Legal Advertisement:
 Doddridge County
 Floodplain Permit Application

Permit #14-264 OXF-43 Well Pad

Huff/Foster comment/objection letter for EQT OXF-43 floodplain application

EXHIBIT F

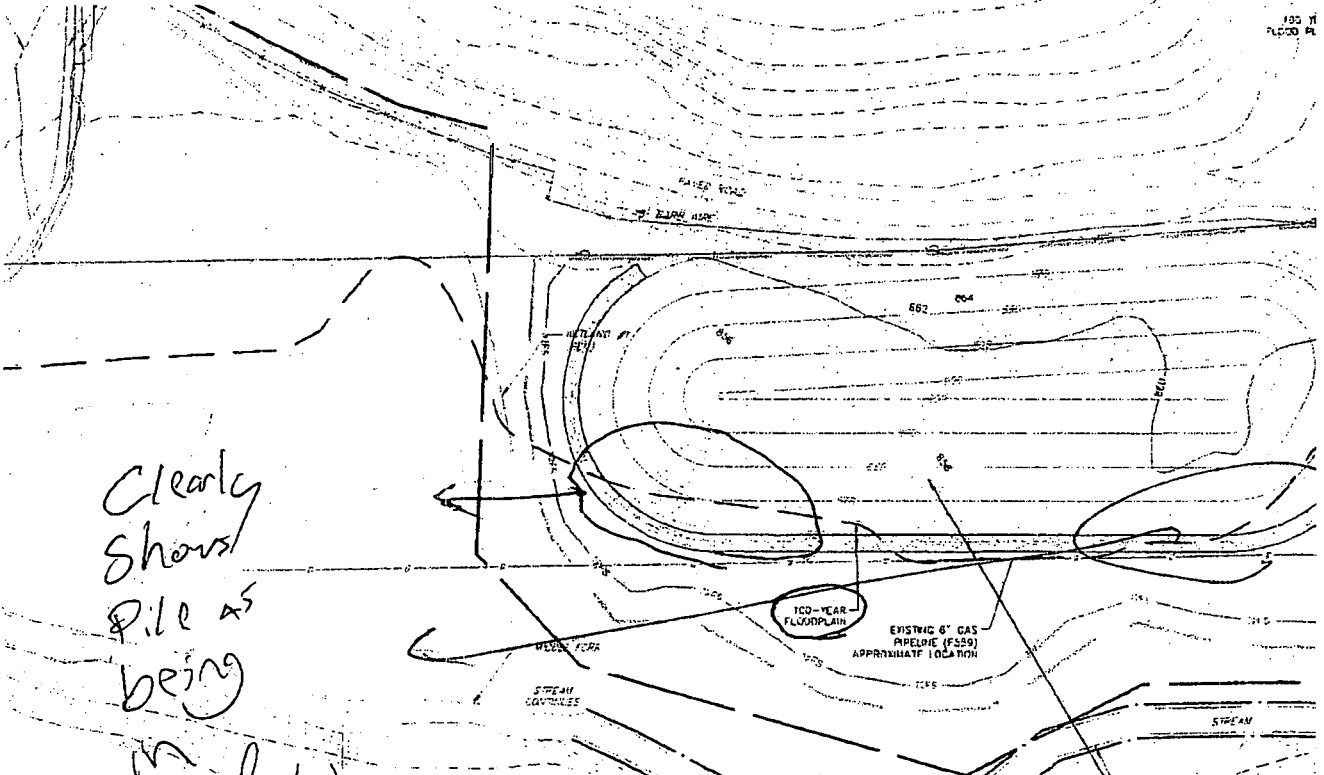
EQT's Application contains a drawing showing that the "spoil stockpile" is outside of the floodplain, and EQT's floodplain "study" attached to its application claims that the "spoil stockpile" is outside of the floodplain. Both the drawing and the floodplain "study" are incorrect. In fact, amazingly, both the drawing and the "study" are directly contradicted by the work of the same engineer responsible for each. Per the attached WVDEP site plans that were signed and stamped/sealed by the same engineer who signed and stamped/sealed the floodplain drawing and floodplain "study", the "spoil stockpile" is IN the floodplain (attached hereto as Exhibit "F" is a copy of the Huff Meadow site plans that EQT submitted to WVDEP to obtain a drilling permit for the Project). Amazingly, the same engineer signed off on and stamped the floodplain drawing, the floodplain "study", and the site plans (i.e., Mr. Eric Hershey, P.E. of Rettew Associates, Inc.). I guess Mr. Hershey couldn't be bothered to be consistent....

Clearly Shows Pile as being in Floodplain

EXHIBIT I

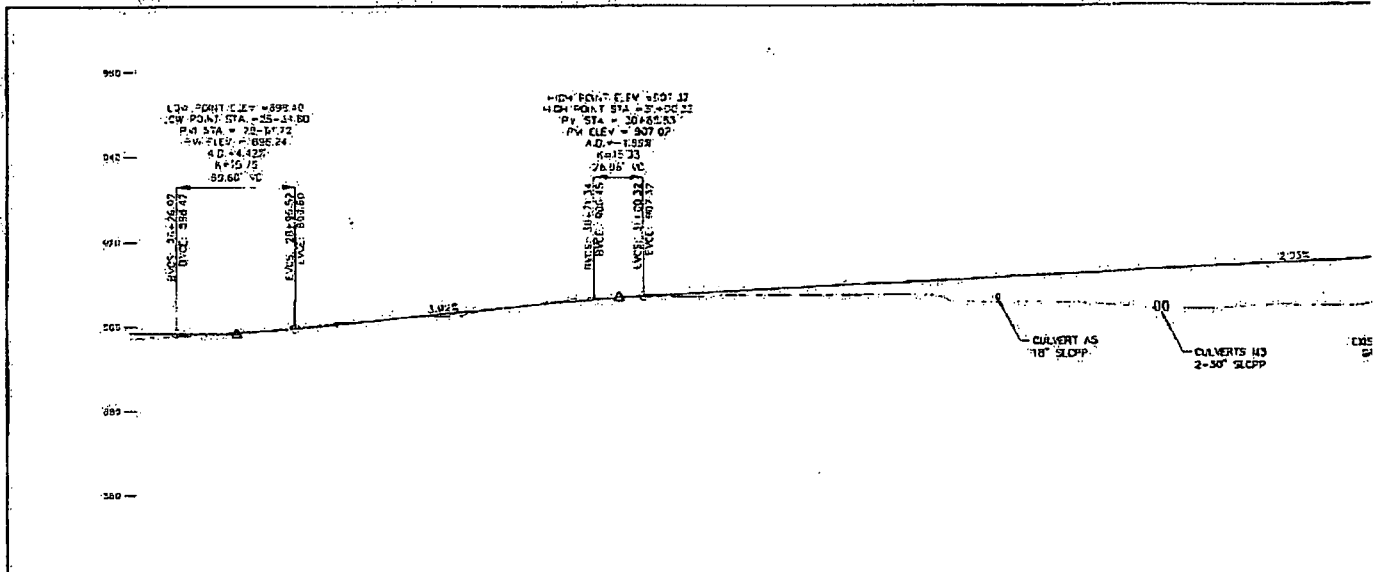
considered 'storage'). Two, there will be an additional fill introduced into the floodplain as part of the development of the "MudLick Run Access Road" (see Exhibit "I" site plans showing fill used to build MudLick Run Access Road, and see both the Rettew floodplain Maps and the Gilbert floodplain Map showing significant portions of the Road will be built in the floodplain, and see "H" fill tables). All told, "Mudlick Run Access Road" will include 37,000 cubic yards of fill. A substantial amount of "Mudlick Run Access Road" will be built in the floodplain, and as such, fill will be added to the floodplain. Note, the provisions of the Ordinance apply to all natural gas developments (see Ordinance pg. 6, #12 definition development...."Any man-made change", and note, there is no requirement that the change be permanent). As such, it is inexcusable for EQT's floodplain Application to fail to admit that fill is going in the floodplain, and it is inexcusable that EQT's floodplain study failed to model said fill. Accordingly, the Application must be denied.
